10 October 2022

DHL Warehouse and Distribution Centre – SSD 36156297 + SSD 5248 MOD 2 Response to Submissions and Project Amendment Report

1.0 Amendments to the Proposed Development

2.0 Response to Submissions

Figure 1 Site Plan – as originally exhibited in the EIS (top) and as amended (below)

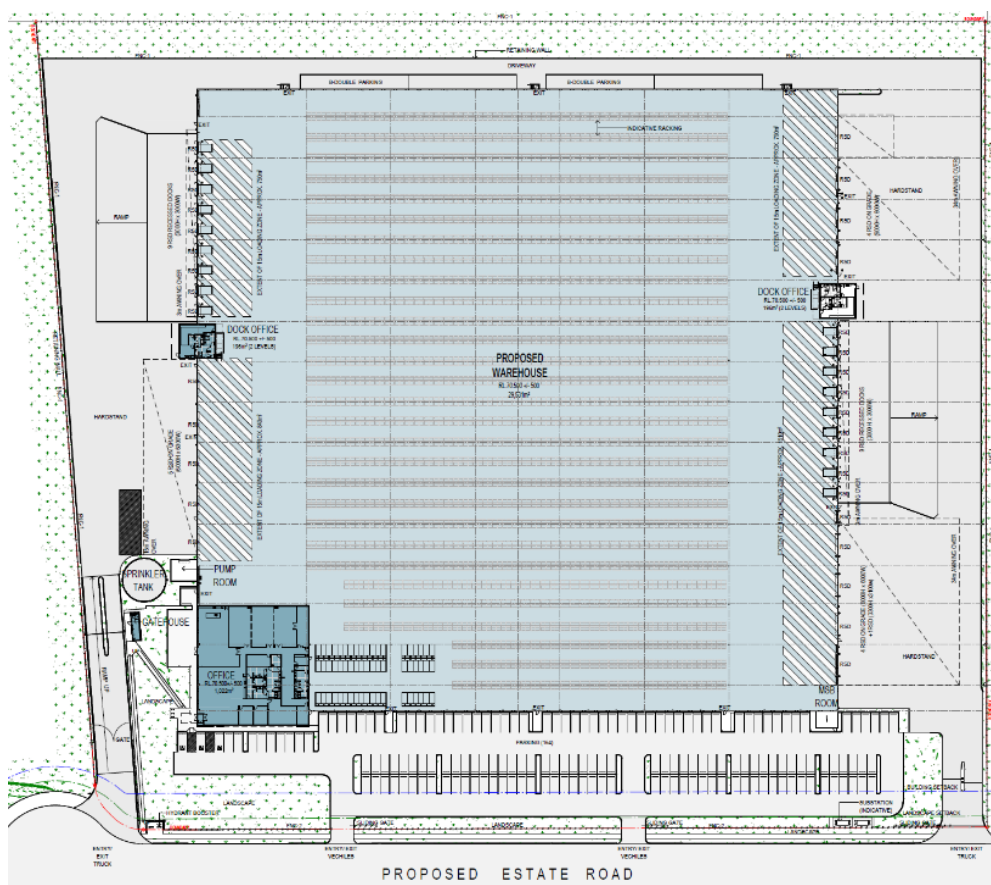
- Elimination of secondary 'VAS Office' as DHL operations no longer requires it.
- Change in configuration of the 'Main Office' to a single level office instead of two levels and a subsequent change to the façade treatment.
- Dock Office on east elevation reduced in size as the larger dock office configuration is no longer required by SHL. The dock office now matches the configuration of the western elevation dock office.
- North East corner of super awning reduced in size to allow a fire truck to 3 point turn without passing underneath an awning.
- Sprinkler tank and fire pump room relocated from south east corner to western side of the site. This was done to reduce the visual impact of this required infrastructure and provide a larger landscaped area to the front of the site.

- Reduction in parking from 194 spaces to 164 due to DHL's operational requirements. Noting the revised minimum required parking spaces is 134, this has allowed for an increase in landscaped area and an elimination of retaining walls in the south west corner of the site which will improve visual amenity.

- Landscaped 'finger' in the North East corner of the site reduced in length to allow a fire truck 3 point turn in this corner of the site.
- Landscape setback to proposed estate road increased from 3m to 4m. More extensive landscaping provided at the entry of the site and around the main office in the south-west corner of the site.
- Species selection has remained largely the same, with the inclusion of an additional Cumberland Plain Woodland species.
- Landscaping has also been revised to comply with the requirements of the bushfire report, including
 - Tree canopies should be separated by 2 to 5m
 - Trees at maturity should not touch or overhang the building
 - Shrubs should not be planted underneath trees.
